#### SERVICE BULLETIN CHANGE NOTICE

S.B. No. A320-21-1001

TITLE: AIR CONDITIONING - TRIM AIR SYSTEM - REPLACE HOT TRIM DUCT (Y-DUCT)

CHANGE NOTICE NO: OA

Figure 1
SERVICE BULLETIN NO: A320-21-1001
PAGE: 7/8

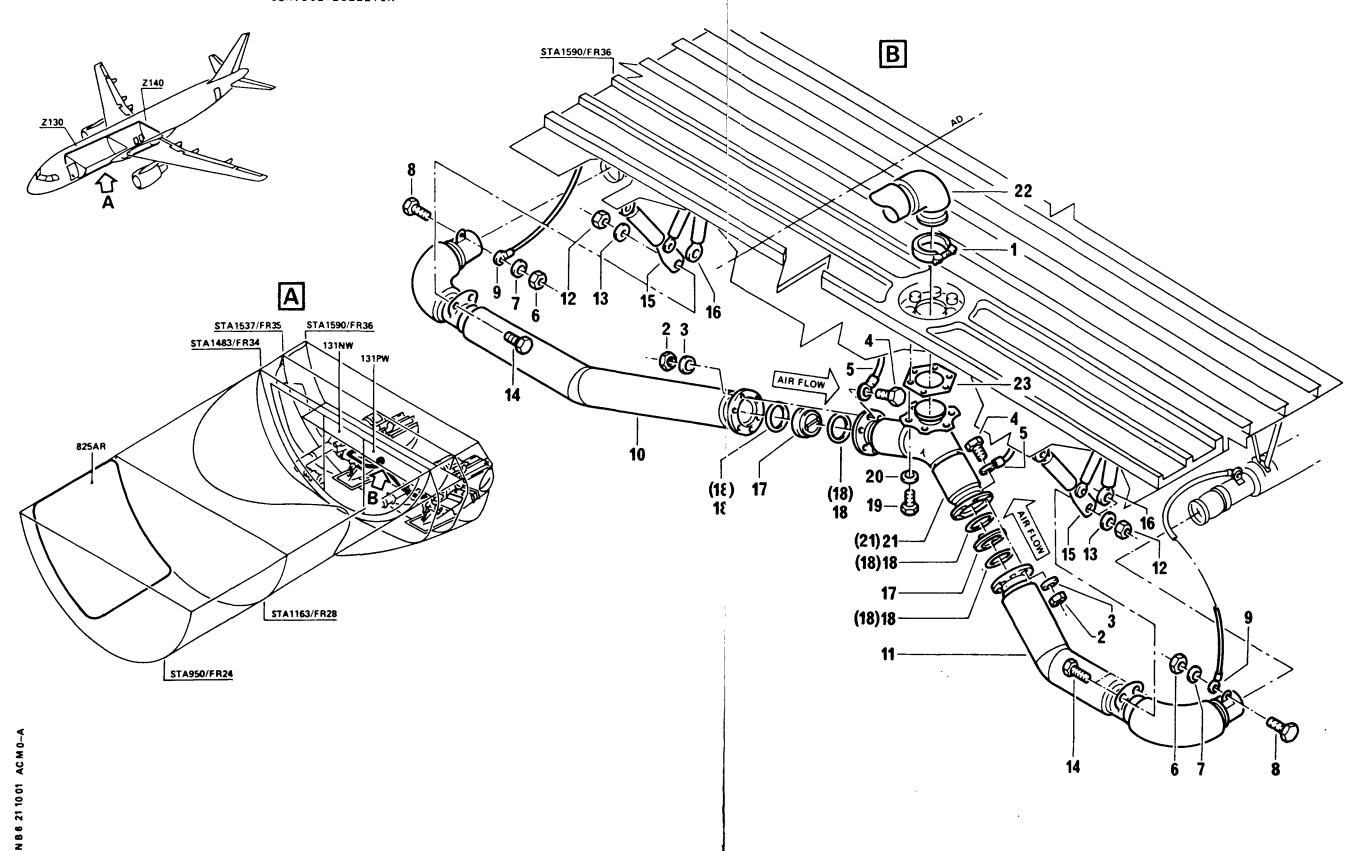
(1) Replacement of the Hot Trim Duct (Y-duct) in the Trim Air System.

Refer to Figure 1

1 Vee clamp item 1 (retain)

- (b) From the right side and the Left side of the hot trim duct (Y-duct), item (21), remove:
  - 12 nuts items 2 (retain)
  - 12 washers items 3 (retain)
  - 12 bolts items 4 (retain)

- (c) From the right side duct, item 10 and the Left side duct, item 11, remove:
  - 2 nuts items 6 (retain)
  - 2 washers items 7 (retain)
  - 2 bolts items 8 (retain)

- (e) Remove:
  - 1 duct (right side) item 10 (retain)
    1 duct (left side) item 11 (retain)
- (f) From the right side and Left side of the hot trim duct (Y-duct), item
  (21), remove:
  - 2 trim air check valves items 17 (retain)
- (g) From the right side and the Left side of the hot trim duct (Y-duct), item (21) and the removed ducts, items 10 and 11, remove:
  - 4 0-rings items (18) (discard)
- (h) At the bulkhead flange on the hot trim duct (Y-duct), item (21), remove:
  - 6 bolts items 19 (retain)
  - 6 washers items 20 (retain)
- (i) From the elbow duct, item 22 and the bulkhead remove:
  - 1 hot trim duct (Y-duct) D2167200000000 item (21) (discard) 1 bulkhead seal item 23 (retain)
  - NOTE: Make sure that the removed components, the component interfaces, the parts which you retained from the removed components and the adjacent area are clean and in the correct condition.

- (j) Put in the correct position on the bulkhead:
  - 1 bulkhead seal D2167200620000 item 23 (retained on removal).
- (k) Install the replacement hot trim duct (Y-duct):

- 1 hot trim duct (Y-duct) D2167200000200 item 21 with
  - 6 washers AN960C416L items 20 (retained on removal)
  - 6 bolts NAS1304-4 items 19 (retained on removal)

- (L) Install in the right side and in the left side of the hot trim duct (Y-duct), item 21 and the removed ducts, items 10 and 11:
  - 4 O-rings NSA8206-145 items 18
